RAM'S HEAD ADDITION TO TILLMAN'S CORNER SUBDIVISION, UNIT TWO, RESUBDIVISION OF LOT 1

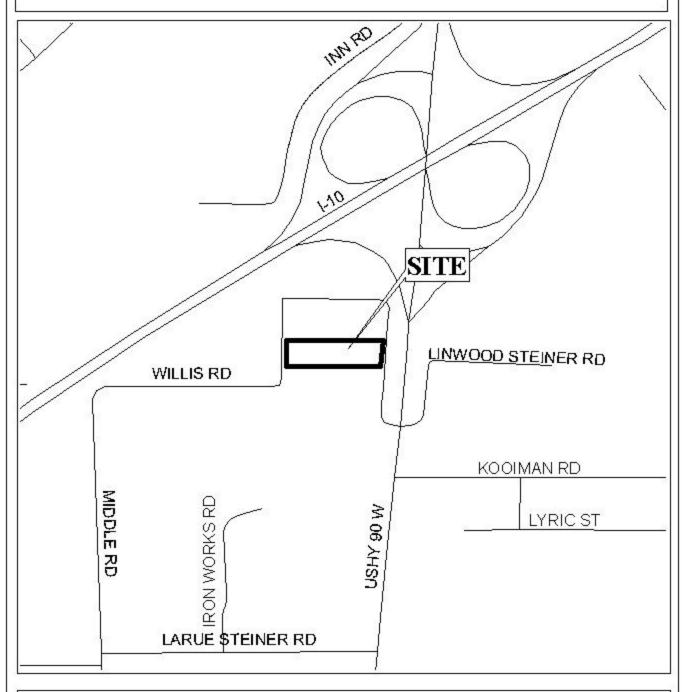
The plat illustrates the proposed 2 lot, $3.2 \pm$ acres subdivision which is located on the West side of U.S. Highway 90 Service Road, extending to the East side of Willis Road. The subdivision is served by public water and sanitary sewer.

The purpose of this application is to create two lots from a legal lot of record.

As illustrated on the plat, Lot 2 fronts a service road for U.S. Highway 90, a major street on the Major Street Plan with an existing 250' right-of-way. The existing right-of-way complies with the Major Street Plan and service roads are an approved method of access management to the Major Street. Additionally, a note should be placed on the final plat stating that crossover traffic between Lots 1 and 2 is prohibited, which was a condition of approval when the initial subdivision was granted on September 4th. Additionally, Lot 1 should be limited to one curb cut to Willis Road with the size, location and design to be approved by County Engineering.

This site is located in the County, thus a note should be placed on the final plat stating that any lots which are developed commercially and adjoin residentially developed property must provide a buffer, in compliance with Section V.A.7. of the Subdivision Regulations.

The plat meets the minimum requirements of the Subdivision Regulations and is recommended for Tentative Approval subject to the following conditions: 1) the placement of a note on the final plat stating that Lot 1 is limited to one curb cut to Willis Road with the size, location and design approved by County Engineering; 2) the placement of a note on the final plat stating that crossover traffic between Lots 1 and 2 is prohibited; and 3) the placement of a note on the final plat stating that any lots which are developed commercially and adjoin residentially developed property must provide a buffer, in compliance with Section V.A.7. of the Subdivision Regulations.
